# HISTORIC AND DESIGN REVIEW COMMISSION

**HDRC CASE NO:** 2021-575  
**ADDRESS:** 417 E LOCUST  
**LEGAL DESCRIPTION:** NCB 1737 BLK 6 LOT 5  
**ZONING:** MF-33, H  
**CITY COUNCIL DIST.:** 1  
**DISTRICT:** Tobin Hill Historic District  
**APPLICANT:** Genevie Livingston/Exquisite Design  
**OWNER:** MERKAVA INVESTMENTS LLC  
**TYPE OF WORK:** New construction of a 2-story duplex structure  
**APPLICATION RECEIVED:** October 29, 2021  
**60-DAY REVIEW:** Not applicable due to City Council Emergency Orders  
**CASE MANAGER:** Rachel Rettaliata

## REQUEST:

The applicant is requesting a Certificate of Appropriateness for approval to construct a 2-story, 1,440-square-foot duplex structure at the rear of the property.

SHEET TITLE:  
Exterior Elevations  
Window Schedule

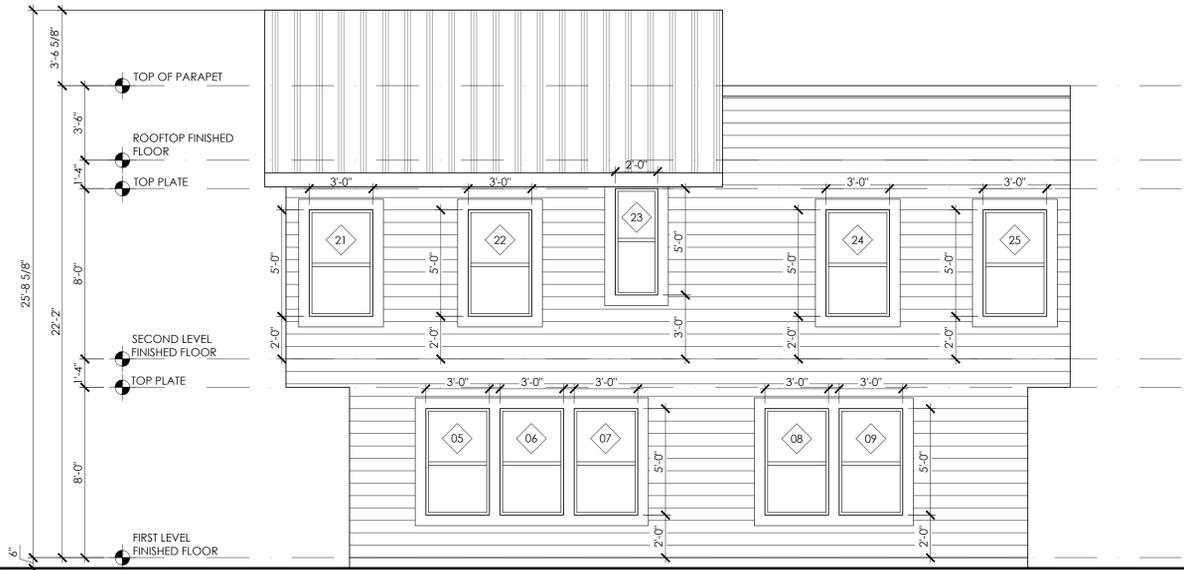
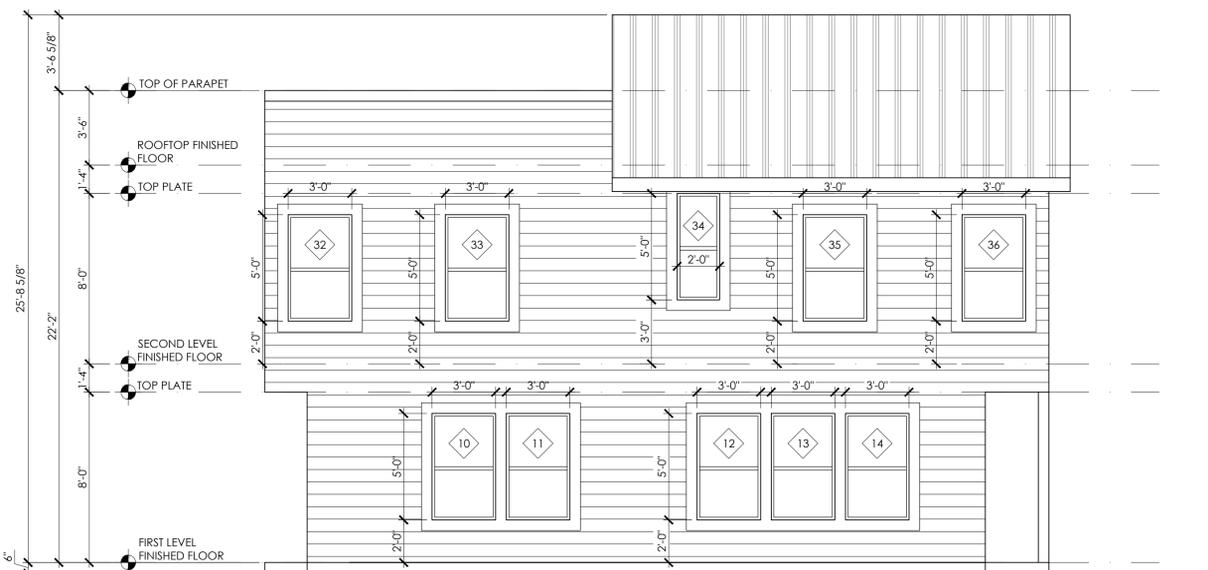
- i. WINDOW & DOOR OPENINGS – The applicant has proposed window and door openings featuring traditional proportions and narrow fixed windows of non-traditional proportions on the south (rear) elevation. Guideline 2.C.i for New Construction recommends that applicants incorporate window and door openings with a similar proportion of wall to window space as typical with nearby historic facades. Windows, doors, porches, entryways, dormers, bays, and pediments shall be considered similar if they are no larger than 25% in size and vary no more than 10% in height to width ratio from adjacent historic facades. Staff finds that the applicant should update the south (rear) elevation to feature window openings with traditional proportions.

JF: The south and north elevation, there is a lack of windows on the first floor. I could see adding additional windows on the north wall, on the other side of the credenza. Staff may have a comment on the quantity and quality of fenestration.

MS: East and west elevation, I would like to see at least one more window on the second floor. If that is on either side of the bed, you could add 2 windows and that would help reduce the massing by incorporating appatures/openings. Another area that could help reduce the massing would be the roof deck wall. Right now, there is 20 feet of siding without any articulation. The railing could be a non-opaque material.

- i. That the applicant submits an updated south (rear) elevation to feature window openings with traditional proportions to staff for review and approval prior to the issuance of a Certificate of Appropriateness based on finding i.
